January 4, 2024

**RE: Sombra del Oeste – PNM Easement
Grading and Drainage Plan
Engineer's Stamp Date: 12/21/23
Hydrology File: M09D032**

SOMBRA DEL OESTE	GRADING & DRAINAGE PLAN
------------------	-------------------------

CD1

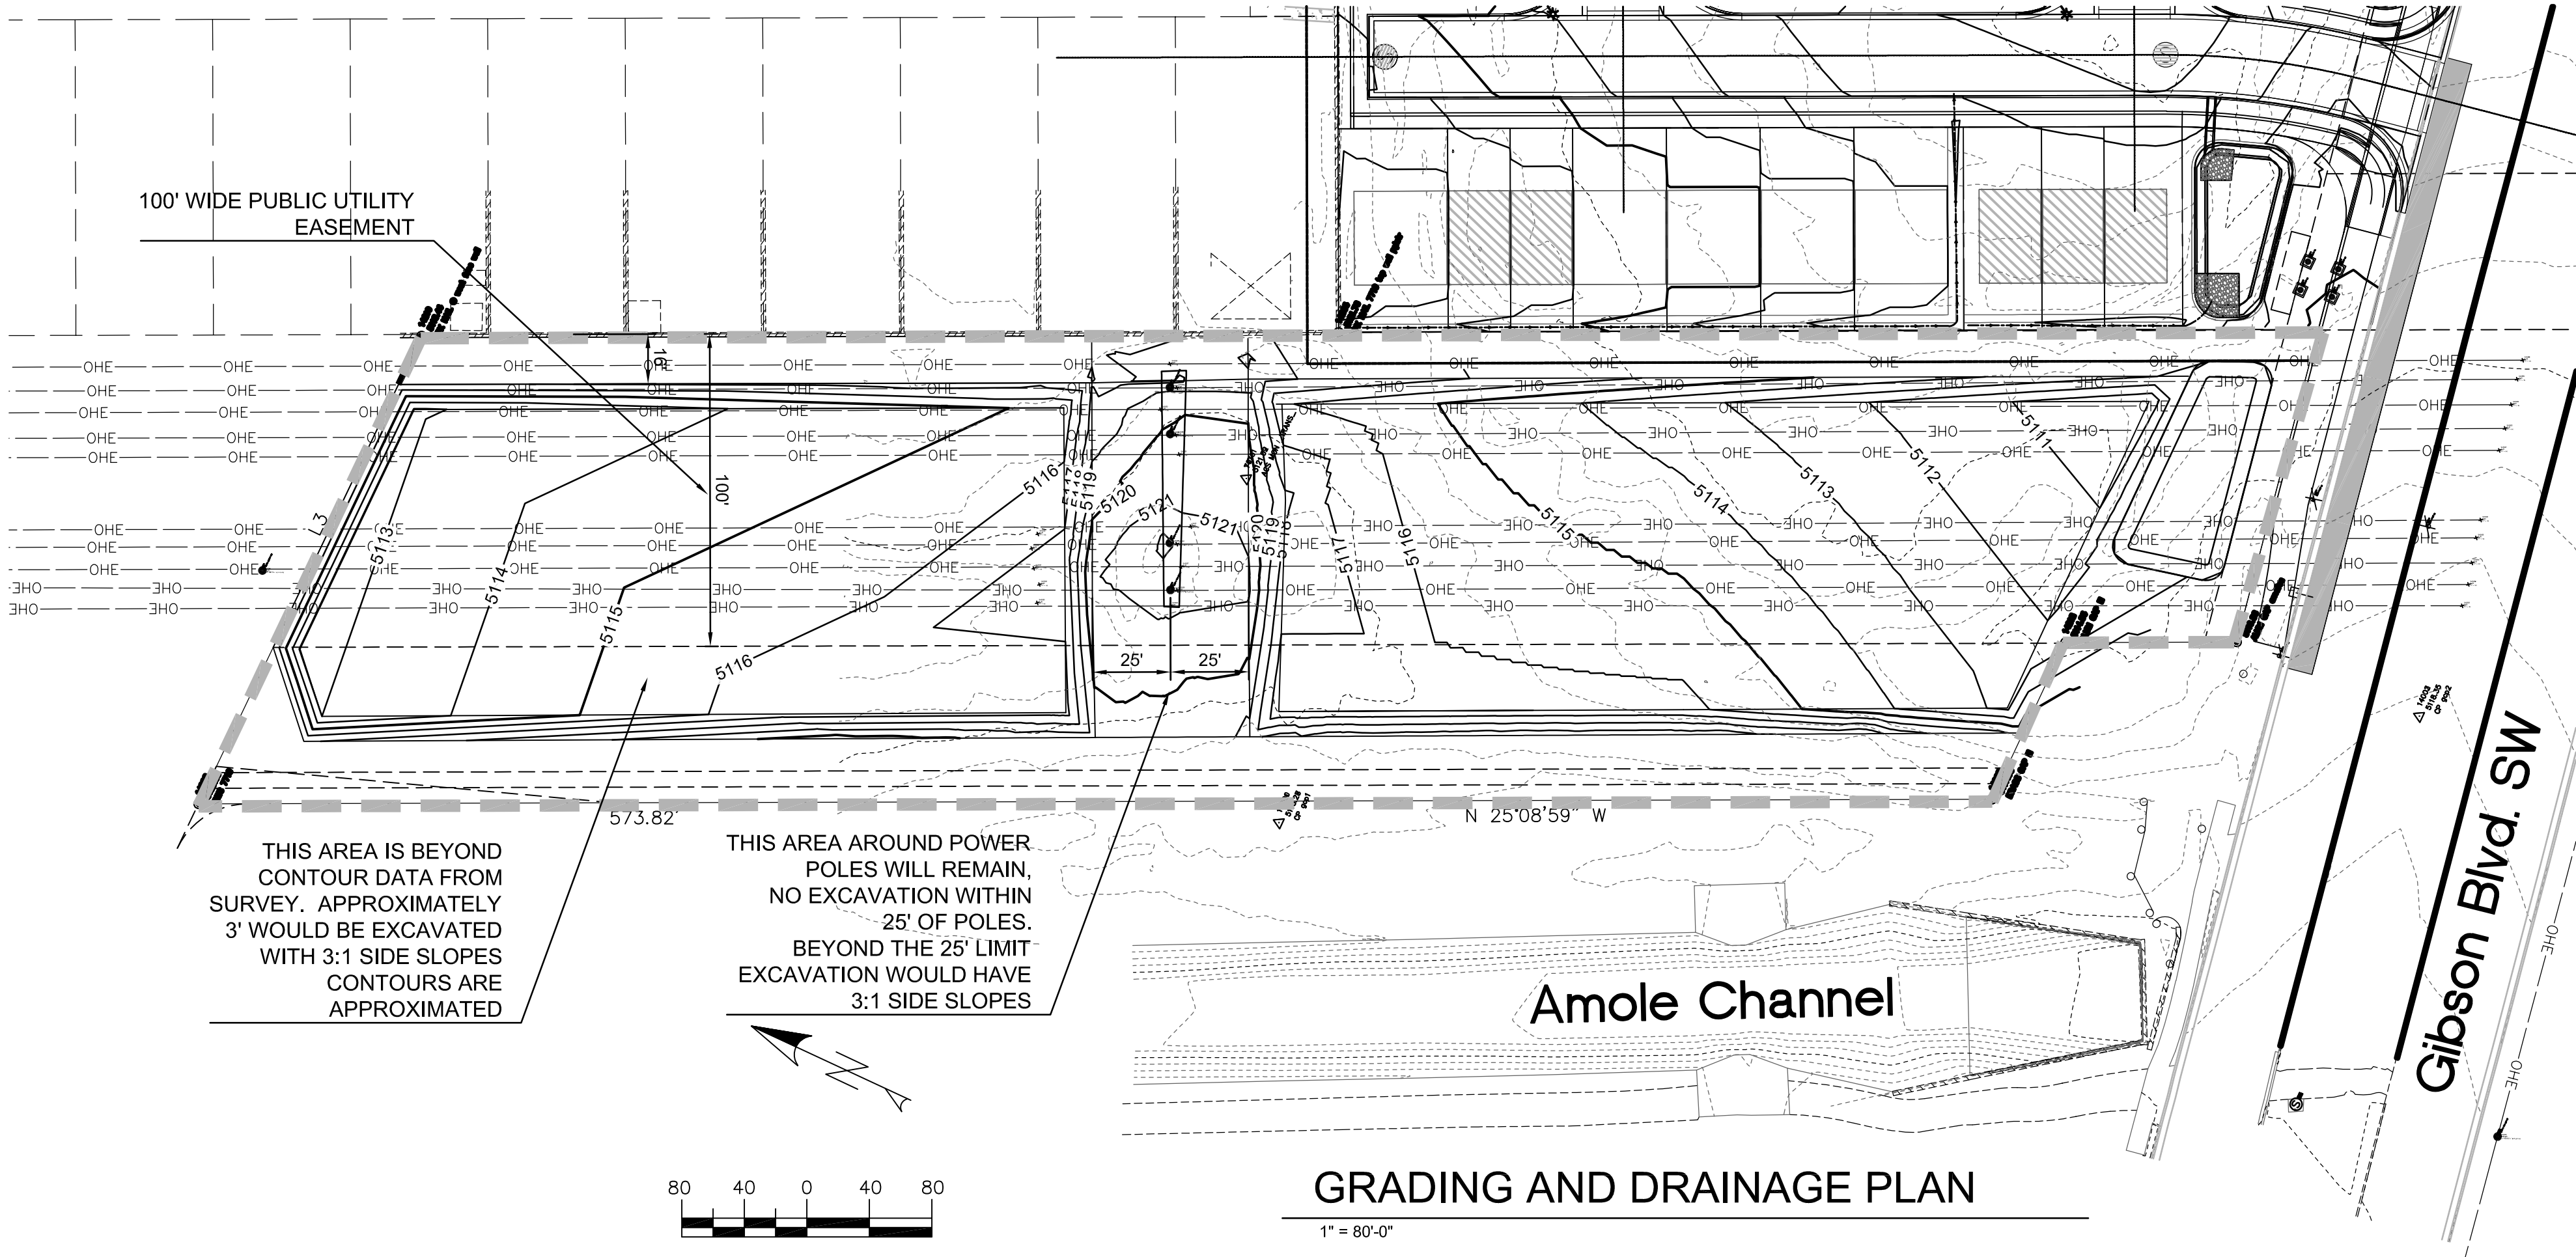
Our access to those structures is from the West. Can you make the flat area extend all the way to the West to keep access to our structures?

We have adjusted the grading near the power poles structures. Attached is the revised plan for you to review.

THE PROPOSED GRADING IN THIS AREA HAS BEEN ESTABLISHED AND COORDINATED WITH PUBLIC SERVICE COMPANY OF NEW MEXICO (PNM). PNM REQUESTED ACCESS FROM THE SERVICE DRIVE ALONG THE AMOLE CHANNEL TO THEIR EXISTING POWERLINE TOWER IN THE MIDDLE OF THE SITE. PNM ALSO REQUESTED NO DISTURBANCE OCCUR WITHIN 25' OF THE TOWERS. WE HAVE DESIGNED THE GRADING PLAN TO MAINTAIN EXISTING CONDITIONS FOR 25' ON THE NORTH AND SOUTH SIDES OF THE TOWERS.
